## Oil Port O-Ring Added to Detroit Diesel BA-921 and BA-922 Remanufactured Compressor Installation Kits

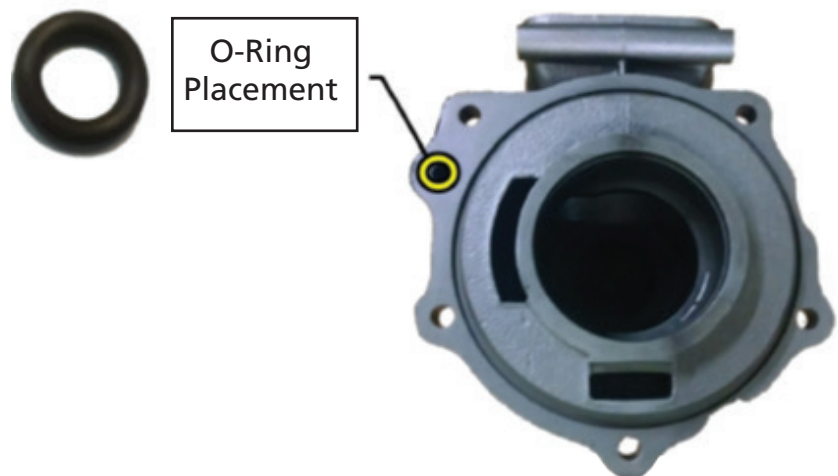
In our continued efforts to better serve our customers, Haldex will now include an Oil Port O-Ring in Detroit Diesel BA-921 and BA-922 Compressor Installation Kits. Use of an RTV Silicone type material is not recommended as this material can be ingested into the compressor's oil port. Instead, Haldex and the OEM recommend the Oil Port O-Ring that will be provided in the Installation Kits for the Part Numbers listed below:

Service Part No.
5012895X
5018485X
5018653X
